**BEFORE THE PUBLIC UTILITIES COMMISSION
OF THE STATE OF CALIFORNIA**

Rulemaking 17-09-020
(Filed September 28, 2017)

**OPENING COMMENTS OF THE CALIFORNIA INDEPENDENT
SYSTEM OPERATOR CORPORATION**

Date: June 13, 2019

Figure 1: Average hourly battery schedules (2018)

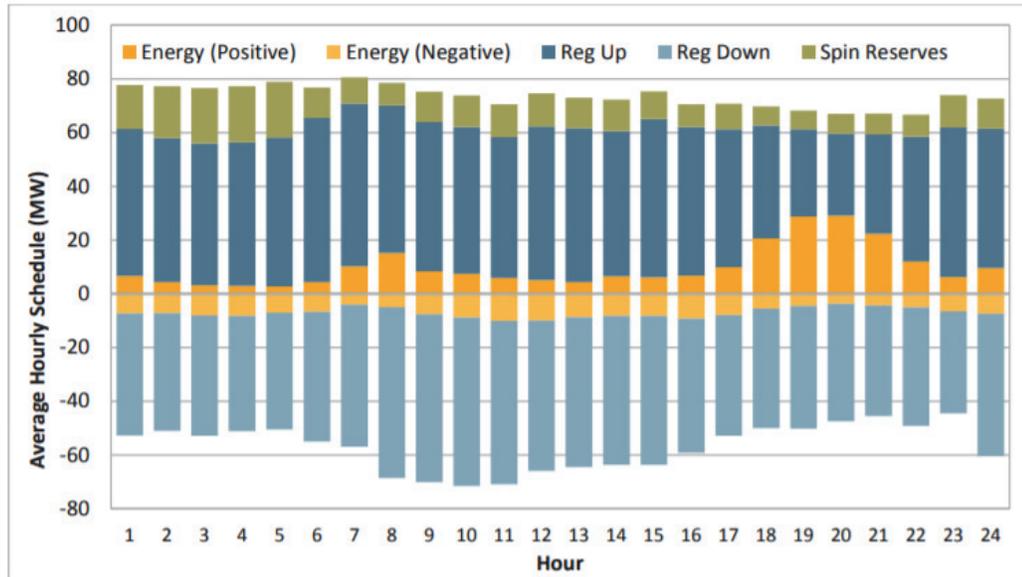
Although modeling exercises are informative, the CAISO urges the Commission to consider whether the operational and market behavior of certain storage technologies aligns with actual operational needs. Figure 1 below presents analysis from the CAISO's DMM regarding 2018 average hourly schedules for battery storage resources participating in the CAISO markets. Figure 1 shows that existing storage resources are largely providing regulation services rather than shifting large quantities of excess midday energy to the late day net load upward ramping period. Contrary to the DMM's findings, current modeling expects storage resources to provide large and favorable load shift and shaping to help meet California's reliability and renewable integration needs.

Given the different short- and long-term operational capabilities, Energy Division should not assume homogeneity of storage technologies in its ELCC modeling. Some storage technologies are well suited for providing regulation while others are better suited to provide bulk energy shifting. ELCC modeling should differentiate between storage technology types because different technologies will have significantly different impacts on the ELCC values for wind and solar resources. In an analogous context, the ELCC modeling already properly differentiates between thermal resources based on their basic operating characteristics (*i.e.*, combined cycles, gas peakers, and nuclear reactors are modeled differently). The ELCC modeling should capture differences in storage technologies in a similar manner.
